Detailed Site Plan

DSP-12049

STAFF REPORT

Little Gifts from God Day Care Center

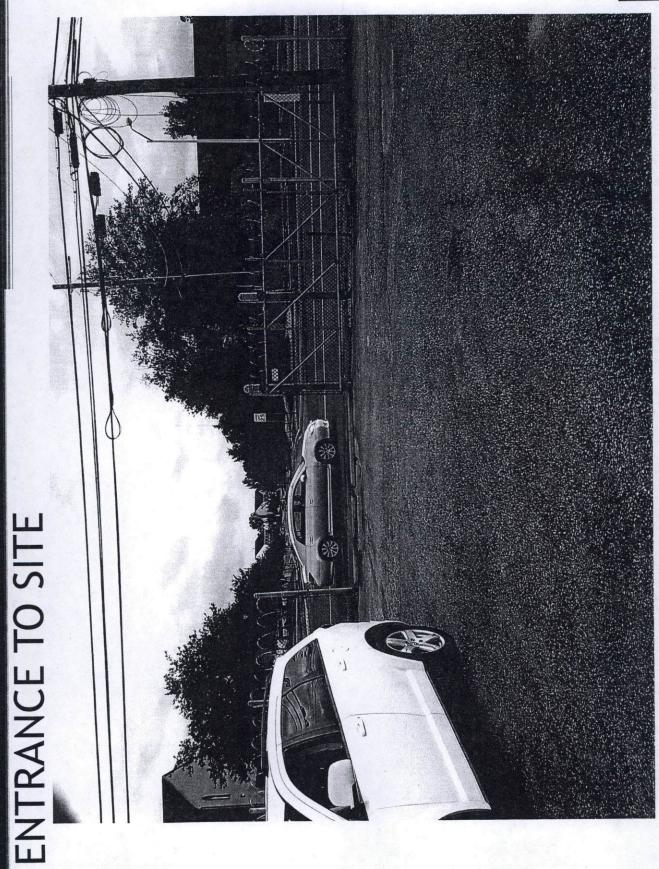
Comment: The submitted DSP does not note this green area requirement being met. However, the 3,000-square-foot play area, as an active recreational area, can be counted towards the green area requirement per Section 27-107.01, Definitions, of the Zoning Ordinance. This area easily meets the ten percent requirement, which would be 1,654 square feet. A note should be added to the plan listing the required and provided green area on-site.

Comment: The plan should be revised to note that the play area will be limited to daylight hours, if that is the applicant's intention. It is not demonstrated to staff's satisfaction that the existing lighting is sufficient for the play area. Therefore, if the play area is to be used after dark, additional lighting will probably be deemed necessary. Staff recommends that industry standard landscape specifications be provided on the DSP to ensure the planting site is properly prepared for the health of the trees.

Comment: The DSP has been revised to show a proposed four-foot-wide gate along the south side of the play area, which will provide an emergency exit to the parking lot area.

- 1. Prior to certification of this detailed site plan (DSP), the applicant shall:
 - a. Add a note listing the required and provided green area on-site.

- f. Revise the DSP to show a minimum six-foot-high, vinyl, sight-tight fence extending along the entire length of the northern, eastern, and southern property lines.

- g. Revise the DSP to show the removal of the chain-link fence along the entire frontage on Old Alexandria Ferry Road, to be replaced with a minimum six-foot-high, black, metal, ornamental fence and a minimum five- to ten-foot-wide landscape strip planted with a minimum of three shade trees and 20 shrubs.

OUTDOOR PLAY AREA

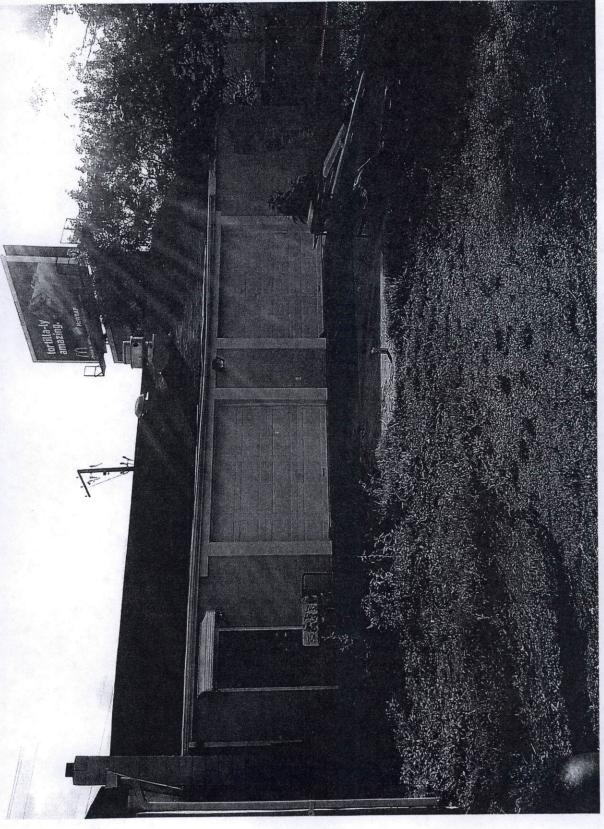
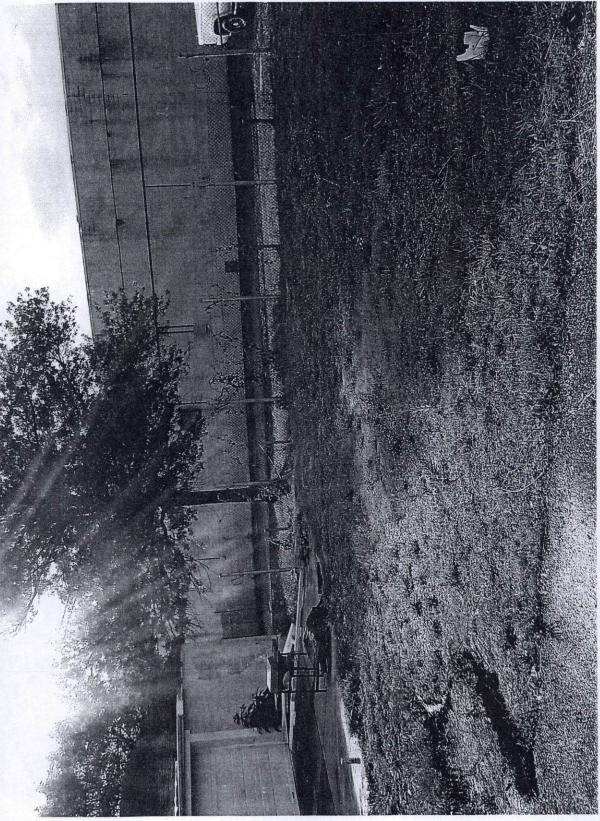
Comment: The proposed play area is bordered by the building on the west and part of the south side. Additionally, the DSP includes a detail for a shade structure that has approximate dimensions of ten feet by ten feet in the central southern portion of the play area, and three new shade trees in the northern portion of the play area. Staff feels this combination of elements will serve to provide sufficient shade to the play area during the warmer months.

Comment: Staff does not believe changes need to be made to the concrete slab within the play area at this time, as the DSP specifies that a safer resilient surface will be installed around it, which will help to mitigate any safety concerns. Additionally, if it were to be leveled off, it could possibly stick up above the ground surface to a point where it would cause more of a safety issue.

- c. Revise the DSP to note that the outdoor play area is limited to daylight hours only, or if the play area is to be used after dark, satisfactory lighting shall be demonstrated on the site plan.
